Voluntary Carbon Standard 2007

Validation Report:

Name of Verification company:	Date of the issue:
Scientific Certification Systems (SCS)	August 31, 2011
Report Title:	Approved by:
Rimba Raya VCS Validation Report	Todd Frank
Client:	Project Title:
InfiniteEARTH	Rimba Raya Biodiversity Reserve Project

This validation assessed the Rimba Raya Biodiversity Reserve Project for conformance against the Voluntary Carbon Standard 2007.1 (VCS) and its supporting documents including the selected VCS approved methodology VM0004 – VM0004 Methodology for Conservation Projects that Avoid Planned Land Use Conversion in Peat Swamp Forests, Version 1.0.

NCR Number 2010.2 of 56 Dated 13th July 2010

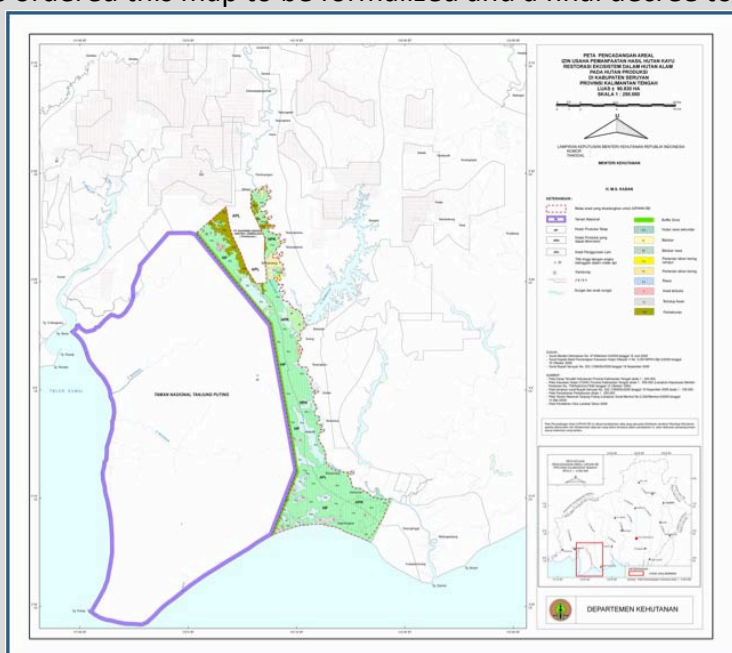
Finding: Please provide the official government issued map of license area boundaries.

Proponent Response: The Ministry of Forestry Area Verification map, shown below has been included as Figure 31 in the updated section 8.1 of the PD. This map shows

the entire Rimba Raya concession (Project Management Zone) which surrounds the project boundary (Carbon Accounting Area) – see below and Figure 2 of the PD. Note that the Indonesian government does not differentiate the (smaller) carbon project boundary but instead recognizes the entire concession within which carbon trading activities are allowed.

Area Verification is a key step in the Ecosystem Restoration License authorization process and is described in detail in the updated section 8.1 of the PD. Briefly, the Rimba Raya PMZ was designated, refined and approved by a series of letters by the Minister of Forestry. These letters have been specifically referenced and are included in a new Annex 12B to the PD. The Minister’s SP1 Letter has conditionally approved the Rimba Raya concession presented in the Area Verification Map. The Minister’s SP2 Letter has ordered this map to be formalized and a final decree to be drafted.

Validator Response: The maps and additional clarifying text related to the Ecosystem Restoration License authorisation process indicates that the project has demonstrated ‘user rights’ to the project areas presented in the PD and supporting documentation. This is sufficient to demonstrate that the boundaries of the project are the same boundaries considered for the Ecosystem Restoration license and subject to the demonstration of ‘user rights’ justified in NCR 1 above.
